## **Addendum**

DS2.1, 2003-08-04

## DELIC-LC/DELIC-PB DSP Embedded Line and Port Interface Controller

PEB 20570/PEB 20571/PEF 20570/PEF 20571 Version 3.1

Figure 1 Clocking the VIP by using DELIC Layer 1 Clock

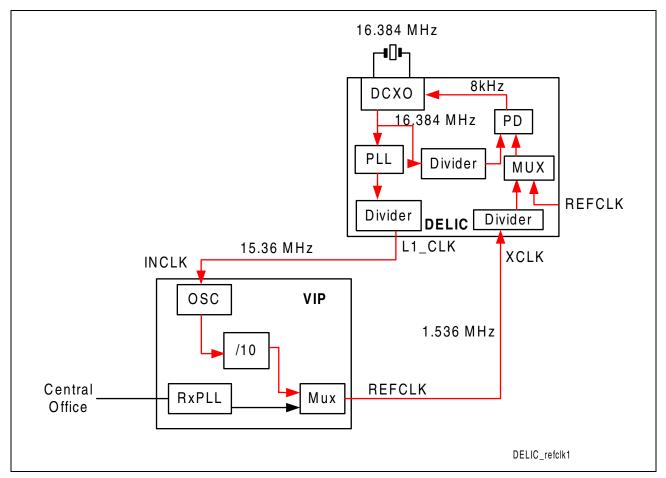
When the Central Office is deactivated, the VIP takes its oscillator signal of 15.36 MHz (the DELIC Layer 1 clock) divided by 10 and uses this signal as DELIC XCLK input as replacement of the Central Office clock.

As a consequence, the DELIC DCXO gets its own signal as input for the PD. Since the second PD input is also generated by the DCXO, the PLL system is unstable. This results in the DCXO and the PLL running to its respective corner frequency. Therefore, the 100 ppm clock accuracy, required by ITU-T I.430, cannot be guaranteed during this time. When switching to another clock source (REFCLK), the DELIC DCXO will work properly again.

The time within the DELIC DCXO guarantees the 100 ppm clock accuracy varies, depending on various conditions. When the central office deactivates, the user will be notified by the DELIC. It is up to the user to provide another clock source (for example REFCLK) for the DCXO as soon as possible.

Note: In LT-T mode it is recommended to use an external crystal to clock the VIP.

Figure 2 Clocking the VIP by using external Crystal

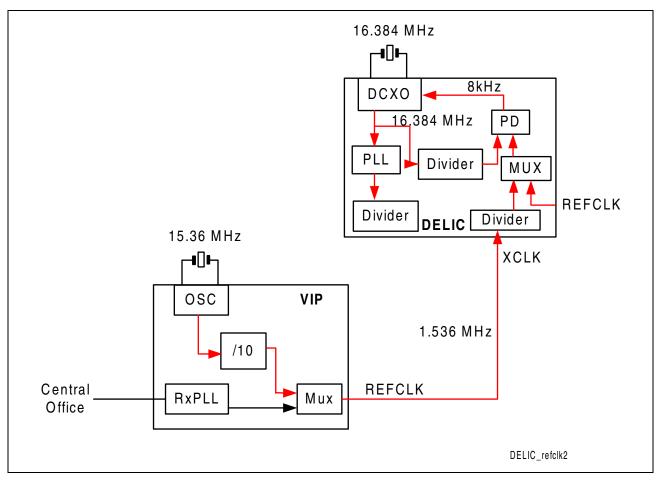
As shown in **Figure 2** no unstable system can occur by using an external crystal rather than the DELIC Layer 1 clock as VIP clock source in LT-T mode. When the central office line is deactivated, the VIP takes the 15.36 MHz oscillator signal and divides it by 10. This signal is used as XCLK input of the DELIC DCXO. Since the VIP 15.36 MHz signal is entirely independent from the DELIC clocking system no unstable system can occur.

Figure 3 Connecting the Crystal to the DELIC

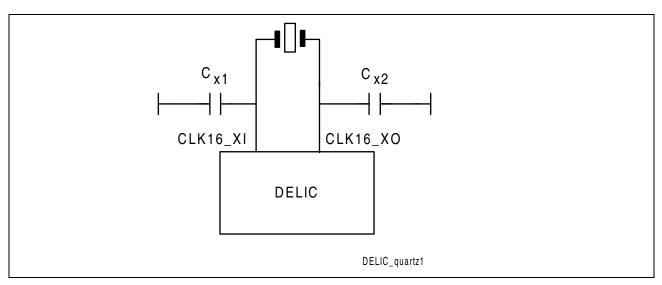
The following table and figures should be taken as an replacement of the "Recommended 16.384 MHz Crystal Parameters" of the DELIC-LC PEB 20570/PEF 20570 and DELIC-PB PEB 20571/PEF 20571.

The DELIC PLL pulls the external crystal by adding/substracting capacitors (internal). By default, half of the internal capacitors are switched on at each pin (CLK16\_XI and CLK\_16XO).

Attention: On the DELIC Evaluation Board (SMART 2057, Infineon)  $C_{x1}$  and  $C_{x2}$  are 3.3 pF each. This value can be used as reference, but depends on the respective board design (for example layout).

### CSTRAP Strap Status Register

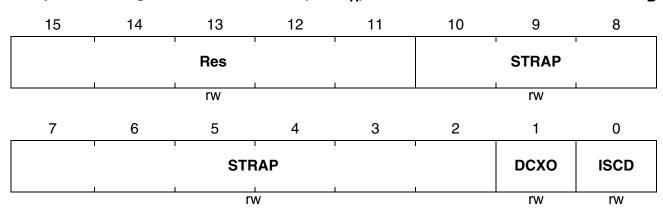
The DELIC "Strap Status Register (CSTRAP)" is described in the DELIC-LC PEB 20570/DELIC-PB PEB 20571 Data Sheet, independent of the version (2.1 .. 3.1). The register description (see updated register CSTRAP) of the Data Sheet is misleading concerning bit 0 and 1. They are **not** configured by strap option. For a stable DCXO synchronization it is recommended to proceed as follows:

- 1. After Boot read register CSTRAP to detect the value
- 2. Set only bit CSTRAP: DCXO to '0' and set the others as detected before
